**Final comments on the Ornithology Addendum
for the
Royal Society for the Protection of Birds**

**Application by Alternative Use Boston Projects Limited for an
Order Granting Development Consent for the
Boston Alternative Energy Facility**

**Planning Inspectorate Ref: EN010095
Registration Identification Ref: 20028367**

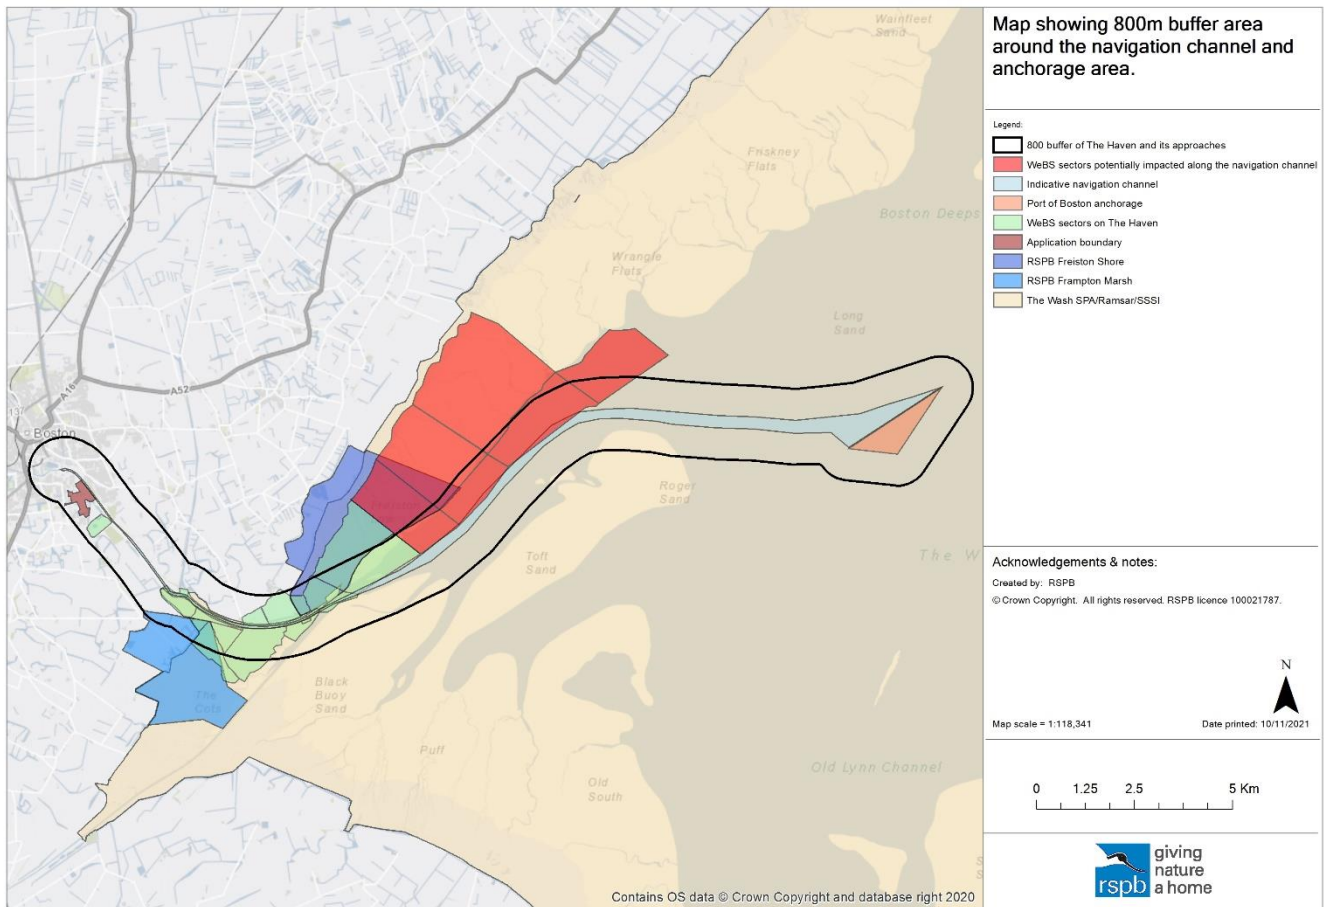
2.7 Consequently, the potential area affected by the application is much greater than currently stated within the addendum and its appendix. Figure 1 shows the anchorage area and the navigation channel, with an 800m buffer. The Applicant's surveys have shown that birds may be displaced even further, with observations of up to 1000m on The Haven and 3300m from the mouth of The Haven. Whilst displacement distances inland from the navigation channel may be less, there is no data available to confirm this to be the case at this time. We consider such an area is needed to be considered in the HRA to ensure the full impacts of the application qualifying features of The Wash SPA/Ramsar are assessed.

- 3.11 This is an unrealistic approach as vessel movements occur along the whole of the navigation channel and as such will cause disturbance to waterbirds along the entire route. Whilst the actual scale of disturbance will vary from species to species, seasonally and even spatially along the navigation channel, no evidence has been collected to demonstrate an understanding of how qualifying features of The Wash SPA/Ramsar use The Haven and the navigation channel out to the anchorage area. A greater area should be used for the impact assessment such as that shown in Figure 1.

Figure 2: Map showing the area along The Haven where no existing data is known to exist on abundance and distribution of qualifying features of The Wash SPA/Ramsar. No data have been collected by the Applicant to determine waterbird abundance and distribution within this area.

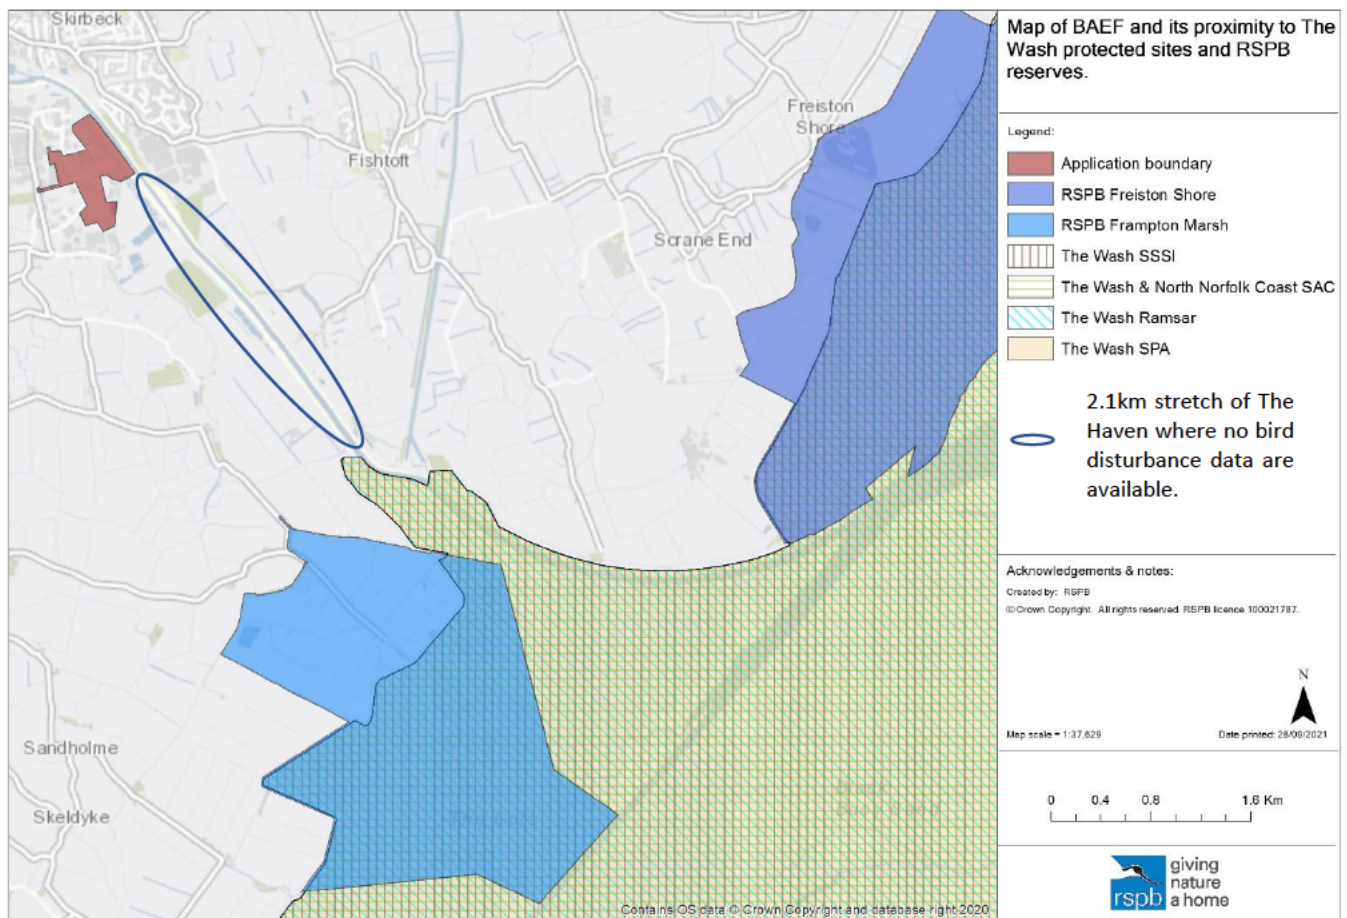
2.8 The Applicant has undertaken some limited ornithological surveys around the Application site and the mouth of The Haven. Whilst the Applicant has limited data for the area around the Application site, the mouth of The Haven, and now has WeBS data for the lower reaches of The Haven from Hobhole, there are no data available for a c.2.1km section of The Haven (Figure 2). Such data are needed to understand the full importance of The Haven for qualifying features of The Wash SPA/Ramsar/SSSI that will be foraging or roosting either within the channel or on adjacent banks. Disturbance from vessel movements will not just be confined to the areas for which data are available but continue along the whole of The Haven.

Figure 3: Map showing the location of behaviour surveys undertaken at Tabs Head looking out onto The Wash. The viewshed for surveyor is provided to show the limited area of the lower reaches of The Haven and the navigation channel that they will have been able to observe during the surveys.

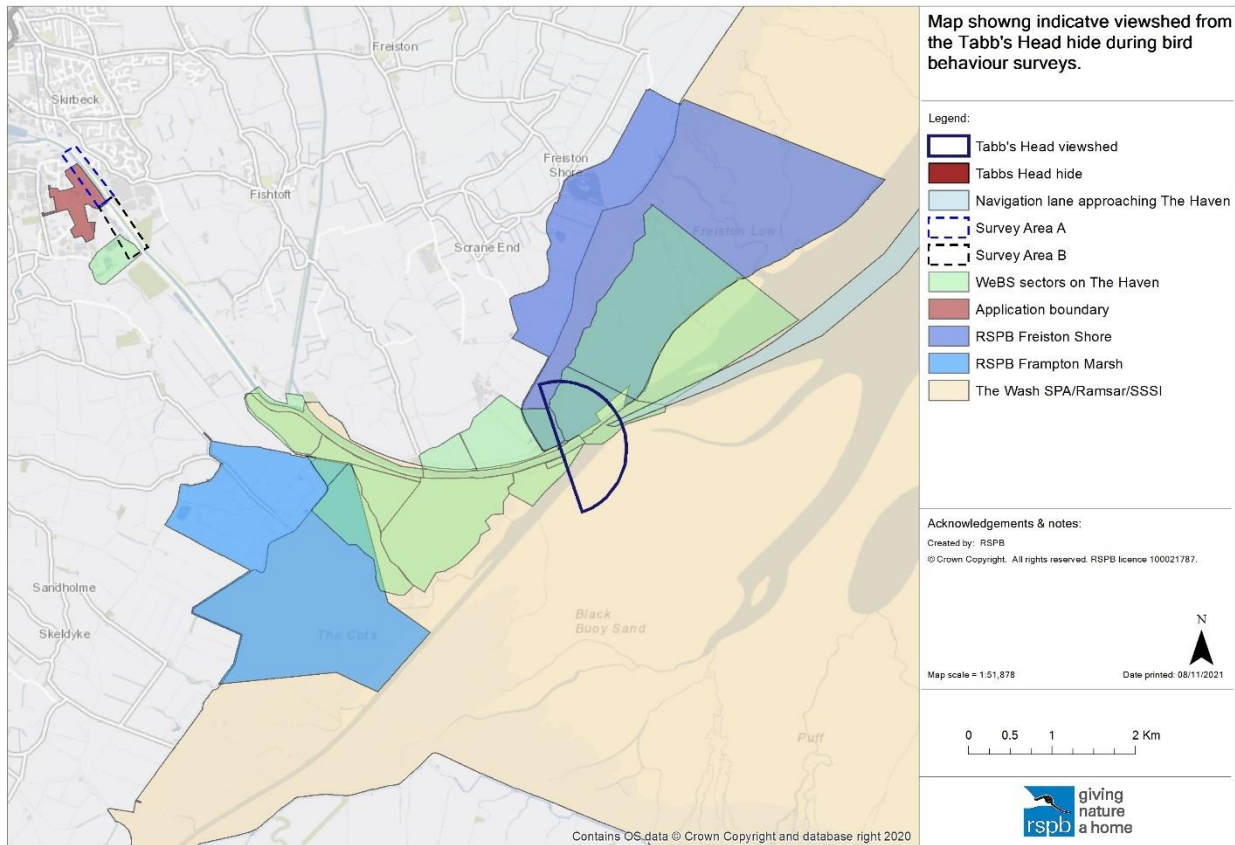
2.12 A specific limitation is that the surveys were conducted looking out onto The Wash from the hide at Tabs Head (Figure 3). This gives a 180° view onto The Wash. However, this does not allow for observations of vessel movements to be observed along The Haven. This is compounded by having only one surveyor carrying out the observations, as additional surveyors would be required to make observations in front and behind the hide. This means that the area of The Wash SPA/Ramsar up to Hobhole could not be observed during these surveys.

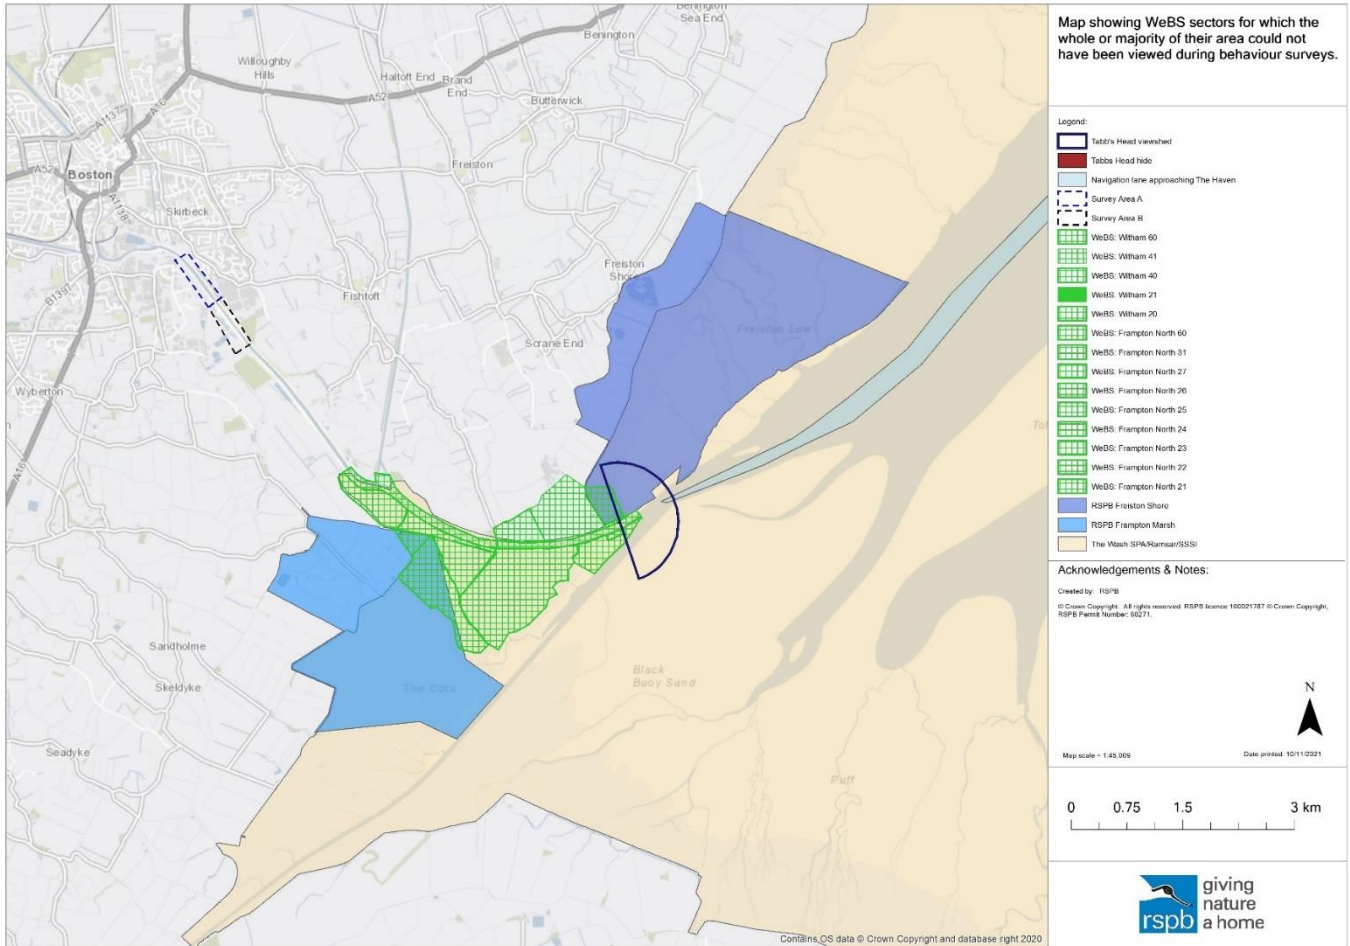
2.13 These are fundamental concerns with the survey approach given the number of sectors that support significant numbers of qualifying features of The Wash SPA/Ramsar, yet no data have been collected to understand the disturbance effect from vessels using the navigation channel through and past these sectors (Figure 4). Whilst the surveys provide useful information, they cannot provide a complete understanding of the effect of vessel movements on qualifying features of The Wash SPA/Ramsar. This is essential to ensure that all areas that could support qualifying features of The Wash SPA/Ramsar are fully understood to know where features roost and forage, the pressures that

they face along The Haven and out into The Wash, and how they respond to vessels and other disturbance pressures. It will not be possible to draw robust conclusions in the HRA where such evidence does not exist.

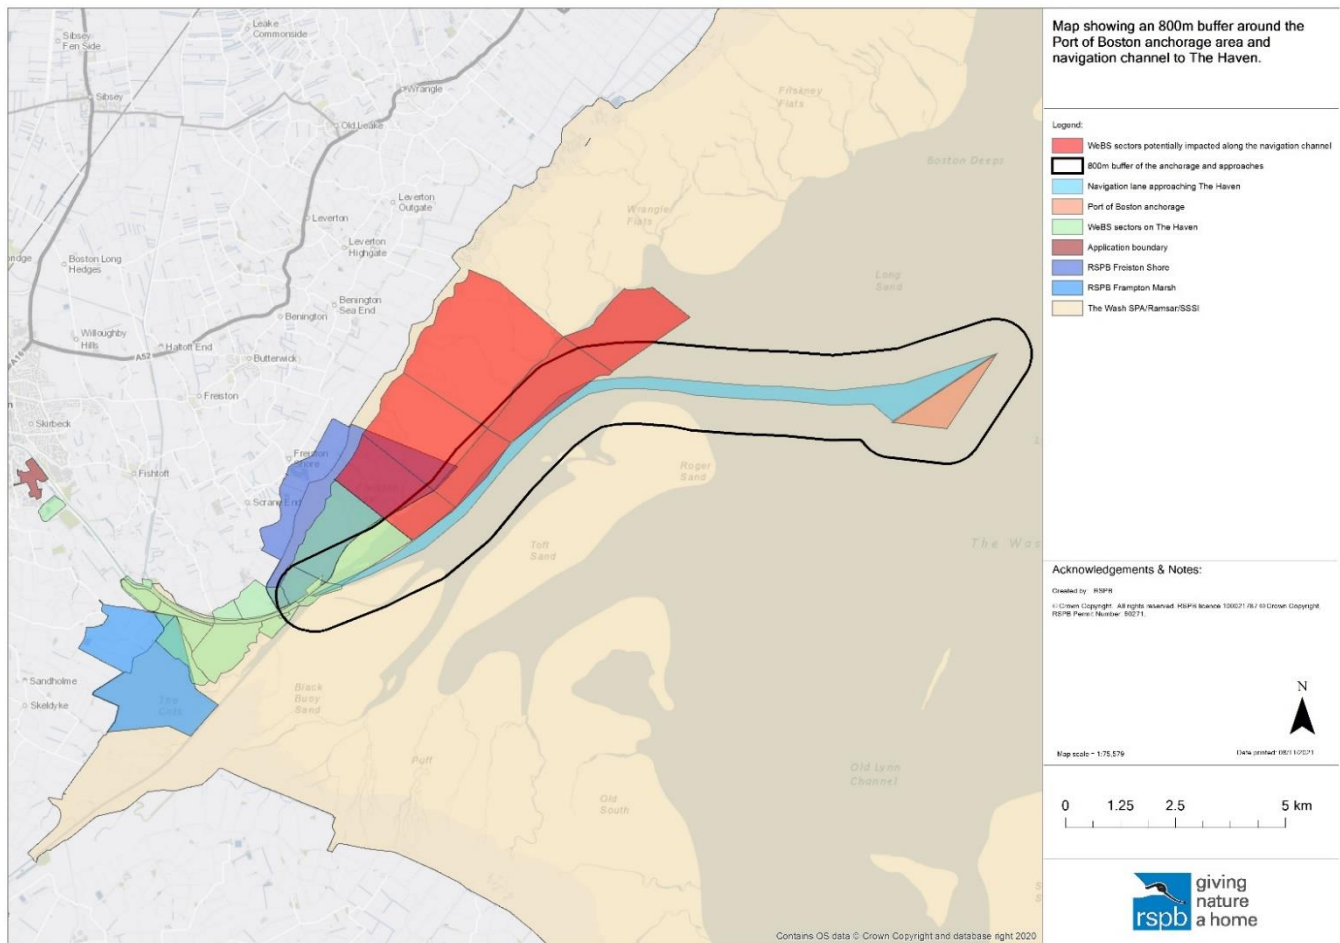
2.14 In our Written Representations, we have identified that there is a lack of data to identify the baseline disturbance levels to qualifying features of The Wash SPA/Ramsar around the Port of Boston anchorage area and the approaches to The Haven. The surveys conducted to date have only observed behaviour changes in waterbirds a relatively small area close to the mouth of The Haven. Figure 5 shows the indicative area of the anchorage area and the navigation channel used by vessels accessing or leaving The Haven. We have buffered it by 800m to be consistent with the observed displacement of birds at the mouth of The Haven to show the extent of the area for which no baseline data exists to rigorously assess the impact that current levels of vessel movements have within The Haven. This is important to assess the current impact that this activity is having on the abundance and distribution of qualifying features of The Wash SPA/Ramsar.

2.15 Figure 5 also identifies that there are additional WeBS sectors along the navigation channel leading to the anchorage area that could be impacted by disturbance from vessel movements. We recommend that the data for these additional WeBS sectors be obtained and included in revised assessments of potential impacts both of baseline activity and during construction and operation of the facility. The Sectors that need to be included are:

- Butterwick 30
- Butterwick 51
- Butterwick 31
- Butterwick 52
- Benington 30
- Benington 50
- Leverton 50
